# Red Caboose/Intermountain 1937 AAR 40' Boxcar - BX-27

By Steve Sandifer

### BX-27

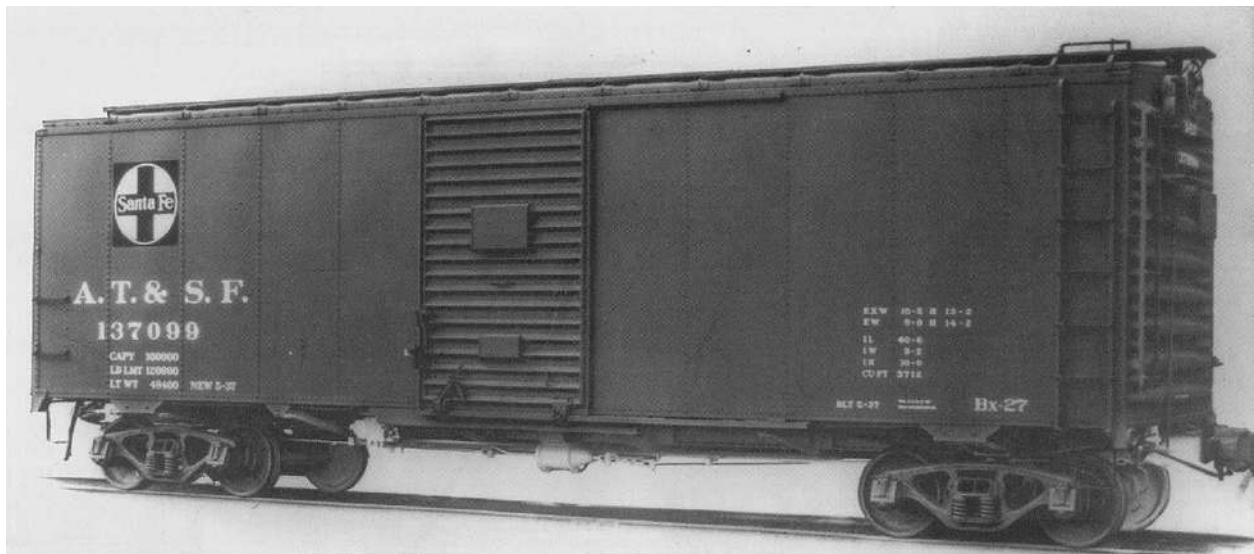
The RC/IMR car lacks the Duryea underframe. Sunshine at one point make a mini-kit for the underframe. The visible point was that the coupler gear extended about 12" beyond the end of the car. Modelers could move the coupler pocket out to resemble this installation.

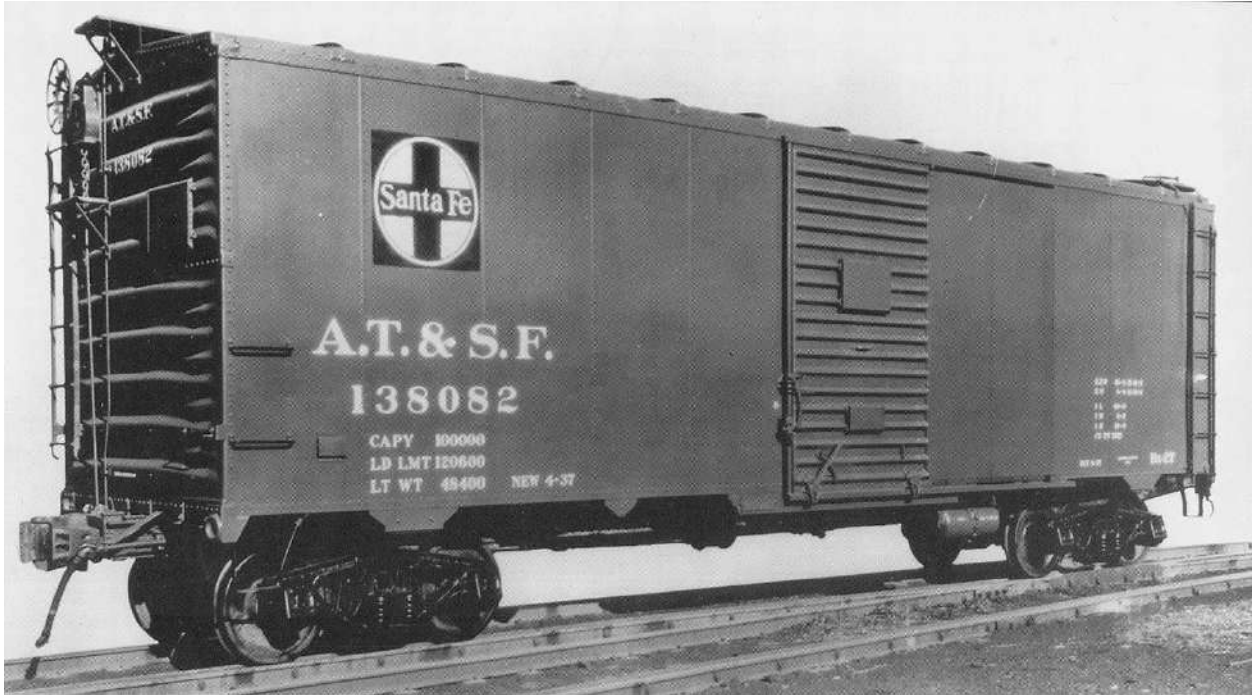
The Duryea frame affect the appearance of the side sill of the car. The ends, sill under the door, and the crossmember ends are all different from the model.

The door stops on the side should be removed.

The BX-27 **ladders** on the sides are incorrect. The left ladder side rail should reach to the roof, which it does not. The end ladders should be 6 rung ladders while the model has 7.

The **grabs** are oversize with large brackets.

The **lower tack board** on the door is much smaller than the prototype.
